UNITED STATES PATENT AND TRADEMARK OFFICE

APPLICATION NO.	FILING DATE	FIRST NAMED INVENTOR	ATTORNEY DOCKET NO.	CONFIRMATION NO.
10/690,933	10/22/2003	Frampton E. Ellis III	ANAT-3USDIV12 (ELL012/DIV)	6928
21302	7590	07/28/2005	EXAMINER	
KNOBLE, YOSHIDA & DUNLEAVY EIGHT PENN CENTER SUITE 1350, 1628 JOHN F KENNEDY BLVD PHILADELPHIA, PA 19103			PATTERSON, MARIE D	
			ART UNIT	PAPER NUMBER
			3728

Office Action Summary

FIG. 27

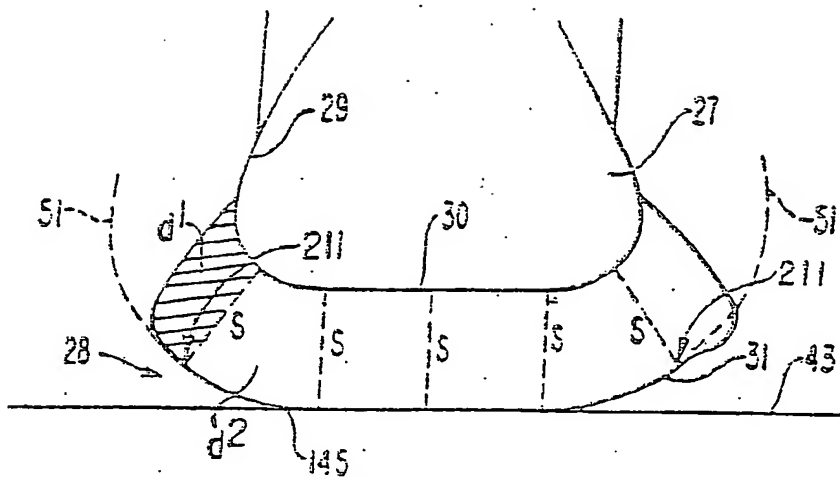
1. The drawings are objected to under 37 CFR 1.83(a). The drawings must show every feature of the invention specified in the claims. Therefore, the shoe sole with both thickness and density variations must be shown or the feature(s) canceled from the claim(s). No new matter should be entered.
